Response to reviewers:

On the manuscript Interactive comment on “**Design and Characterization of a new OFR: The Particle Formation Accelerator (PFA)**” by Xu and Collins., submitted to Atmospheric Measurement Techniques.

Response to Anonymous Referee #1

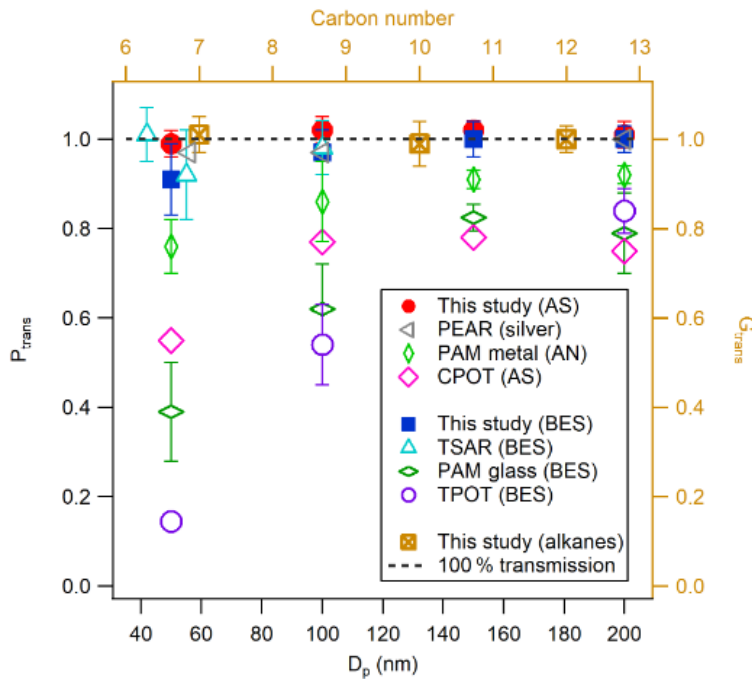
The comparison of particle penetration efficiencies is incomplete, and in some places is misleading. Figure 7 shows that the size-dependent particle penetration efficiencies of PFA, PAM and TPOT OFRs, and as presented, suggests that the PFA performance is the best of the three. However, as noted in L215-L220, the PFA was conditioned for 12 hours prior to testing to suppress static discharge, whereas the other OFRs were not. Thus, results are a combination of OFR design and testing procedure, and how to isolate the relative importance of each factor is not clear. Either results for the PFA prior to conditioning also need to be shown for a direct comparison, or this difference needs to be more clearly identified in the figure/caption. Figure 7 also does not show published particle transmission efficiency data for several other OFR designs that were already referenced in this paper. Please see Figure 2 from Li et al., 2019, reproduced below for reference; to my knowledge, this is the most comprehensive comparison to date:

Answer: We added the data for the CPOT, TSAR, and ECCC-OFR to the revised [Figure 6](#). The results are not meant to be misleading. Our intent is to always minimize charge prior to

measurements. Though we have not tested this extensively yet, it is our belief that the charge will not return until and unless the OFR is disassembled or relocated.

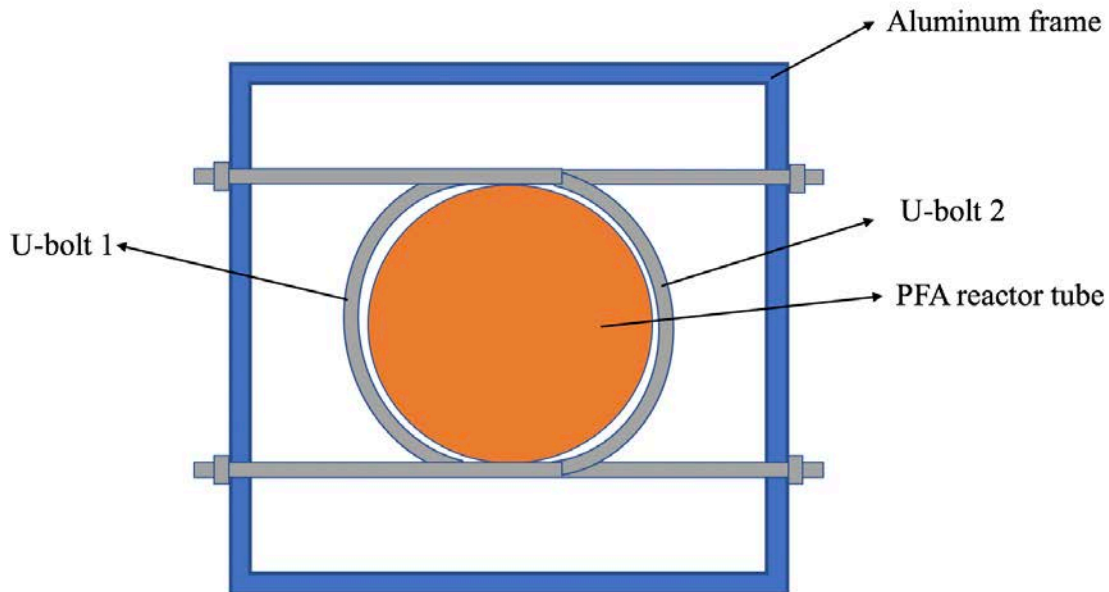
- 4. About the lamp: if I understand correctly, the lamp is exposed directly to the flow? Also, since Sections 2.6 & 3.2 presented the experimental measurement of light intensity as a function of the distance to the bottom, it is worth mentioning it in Section 2.1 at least or rearranging the two sections.**

6. **Line 142: it is not very clear how the two U-bolts hold the tube inside the aluminum tube.**

Answer: Yes, the lamp is exposed directly to the flow, but only the side flow after it is split from the sample flow. So there is no contact between the sample flow and the lamp surface. We added a sentence clarifying this in the revised paper.

Answer: Those two U-bolts are mounted through opposite sides of the square enclosure as shown in the top view sketch below.
